City of Lone Tree Planning Commission Agenda Tuesday, June 10, 2014

SUBJECT: RidgeGate Section 15, Filing 21, Lots 4 and 5
Site Improvement Plan, Project File #SP14-26R

Approval of a Site Improvement Plan (SIP) for 57 single-family attached units on 3.48 acres.

RIDGEGATE SECTION 15, FILING 21, LOTS 4 & 5
SITE IMPROVEMENT PLAN
OVERALL SITE PLAN

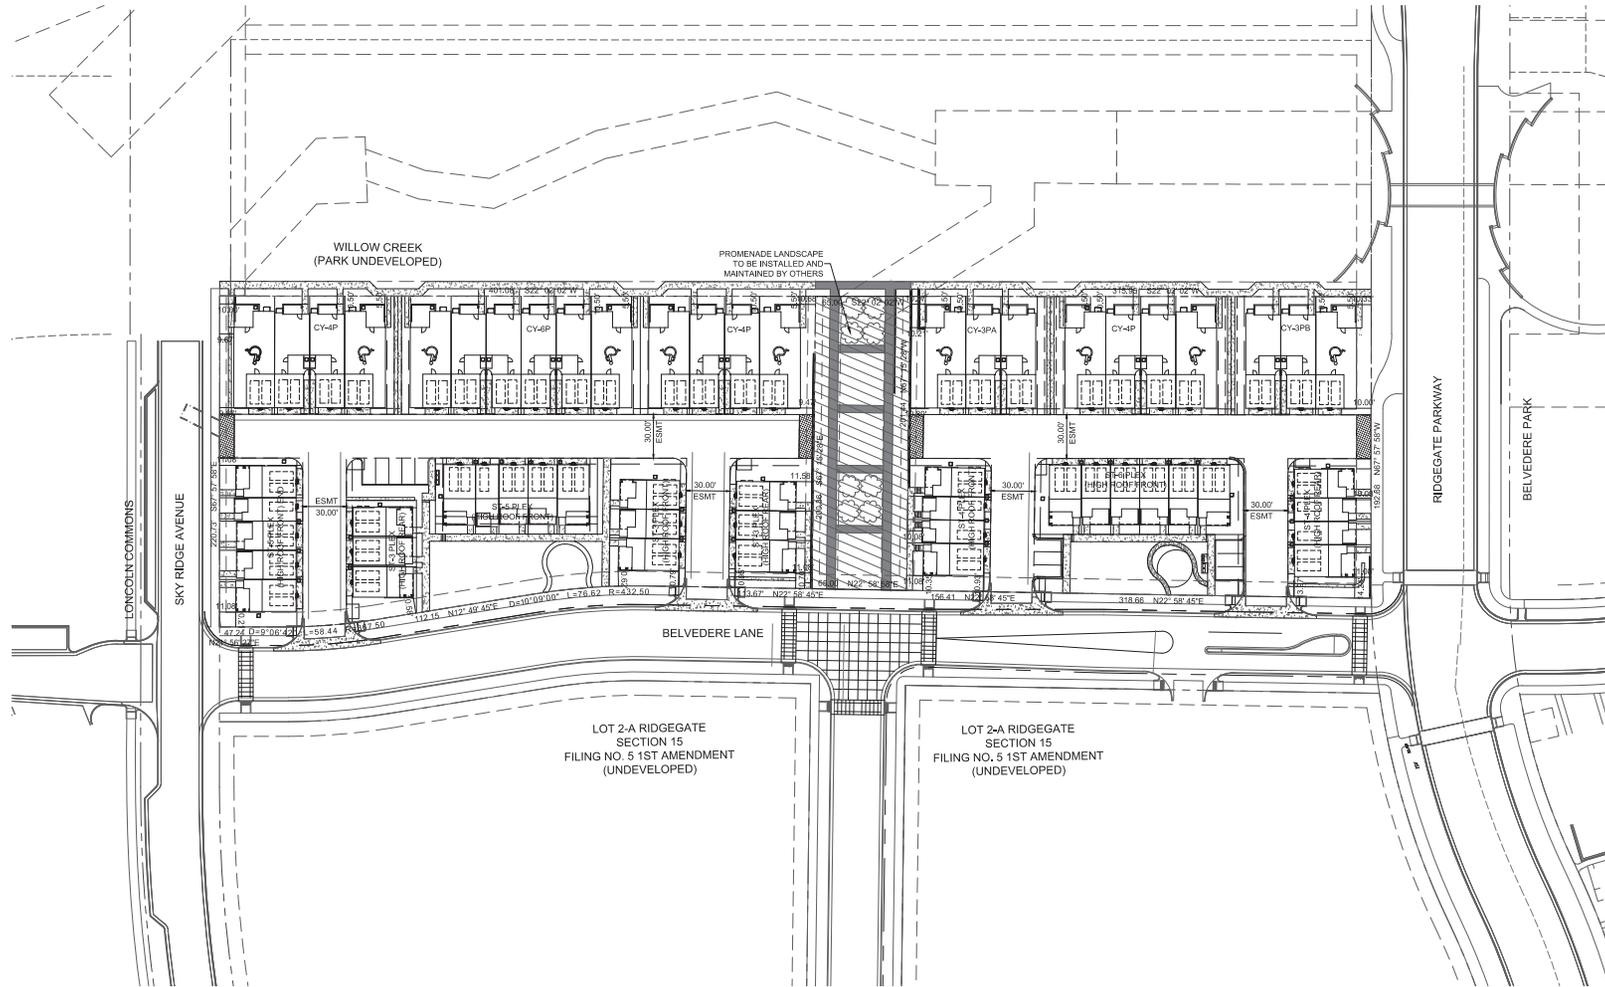
1. Sheet 1 – Cover Sheet:

- a. The Site Data Chart indicates that the nine (9) on-street parking spaces shown on the Belvedere Lane frontage of the north segment (e.g. Lot 4, SIP Sheet 2 & 3) are counted toward meeting the indicated required 128 parking spaces. Although, as shown on Sheet 3, these parking spaces are in conflict with the driveway-street intersection line of sight requirements, per City adopted Douglas County Roadway Design and Construction Standards, (Section 4.11.4), parking within the sight triangle may be allowed on local streets. This portion of Belvedere meets the design criteria for the DC referenced "local streets", and the proposed parking would therefore not be precluded.

RIDGEGATE SECTION 15, FILING 21, LOTS 4 & 5
 SITE IMPROVEMENT PLAN
LOT 4 SITE PLAN

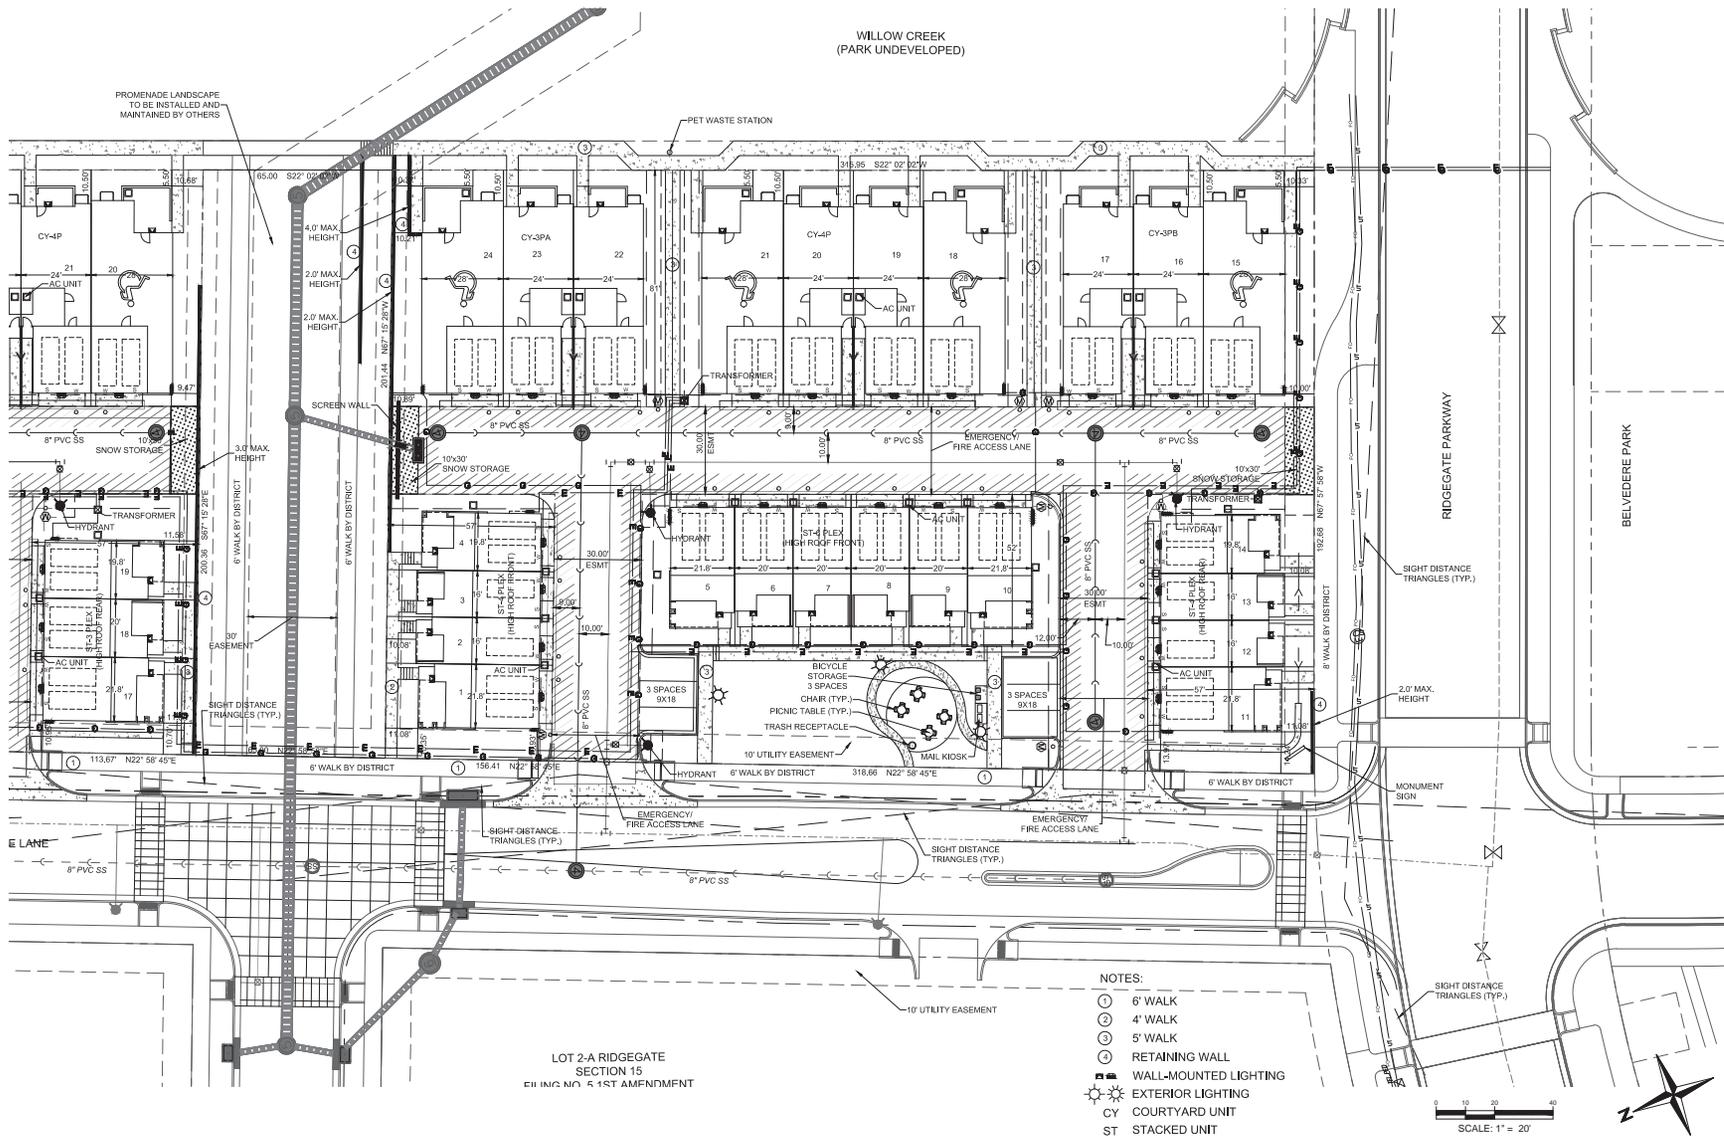
2. Sheet 3 – Lot 4 Site Plan:

- c. A proposed fire hydrant is shown adjacent to Belvedere Lane on the north side of the north drive. Consistent with the location of a similar hydrant on the Lot 5 site (see SIP Sheet 4), it may be desirable for fire department access (to connect and pull hoses) to have the Lot 4 hydrant located on the south side of the drive. South Metro Fire and Rescue should review and approve the proposed hydrant locations and also the "No Parking – Fire Lane" signage locations for the proposed New Town development.

- d. At three locations in the development (one on the north portion - between units/lots 29&30, and two on the south -- between units/lots 17&18 and 21&22) space is maintained between the adjacent units to include a 5' connection from the drive to the Park walkway. However, between units/lots 23&24 on the north portion, this connection has not been provided. In this location, the space between the adjacent units is narrower by 6' than in the other similar locations. The loss of this connection walk apparently was a trade-off in order to obtain two (2) added "Handicapped" units.

- e. The sidewalk along the east side of the Project, in the adjacent RRMD "Tract A" is being designed by the RRMD's Landscape Architect. The sidewalk should be shown in conformance with the RRMD Park design and appropriately labeled as "by others". Coordination/approval of the proposed connection(s) from the New Town Project to the RRMD sidewalk must be confirmed by the RRMD, or the on-site New Town design should be modified appropriately to eliminate the off-site work/connections. We recommend resolution of this issue prior to SIP and/or Plat finalization and approvals, and prior to final engineering plans approvals.
